# Certificate of Appropriateness

**2617 N. Wahl Avenue**

**North Point North HD**

Repairs at the SE area of the roofline.

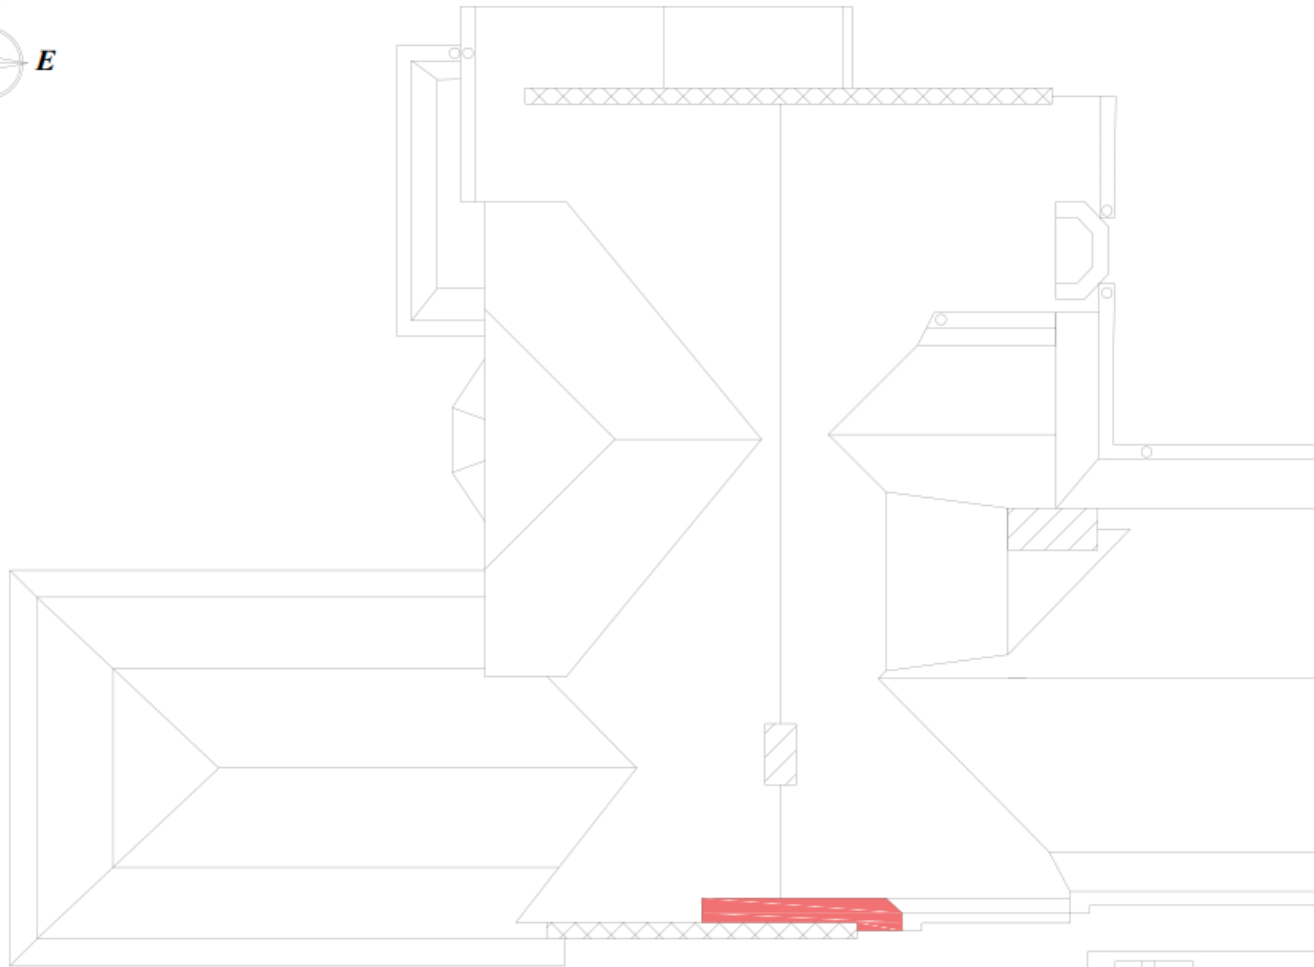
- A) Erect scaffold staging to access the upper southeast roof area.
- B) Carefully remove the existing slates and ridge metal from the upper southeast highlighted roof area and set aside for re-installation.

- C) Remove the existing parapet wall flashings from the highlighted roof area.
- D) Remove the existing felt underlayment from the exposed roof area down to bare wood deck and dispose of.

times the height of the joint before repointing. When installing new flashing at a masonry feature, the flashing must be stepped or cut into the mortar joints. The bricks may not be cut to install flashing at an angle.

No dormers, chimneys, moldings parapets, or other permanent features will be altered or removed. No box vents, if used, will be visible from the street. If they are installed, they must be on a rear slope not visible from the street and they must be painted to blend with the color of the roofing material. A continuous ridge vent can be installed in place of box vents, but the vent must extend across the entire ridge and not stop short. Built-in rain gutters will be retained and patched where needed. Valleys must be metal W-shape with no interweaving of shingles. Valleys and flashing must be painted or factory-finished to match the roofing color, unless copper. When installing new flashing at a masonry feature, the flashing must be stepped or cut into the mortar joints. The bricks may not be cut to install flashing at an angle. The Wisconsin Historical Society has established best practices for working with slate roofs. The City strongly recommends following their advice. <https://www.wisconsinhistory.org/Records/Article/CS4263>
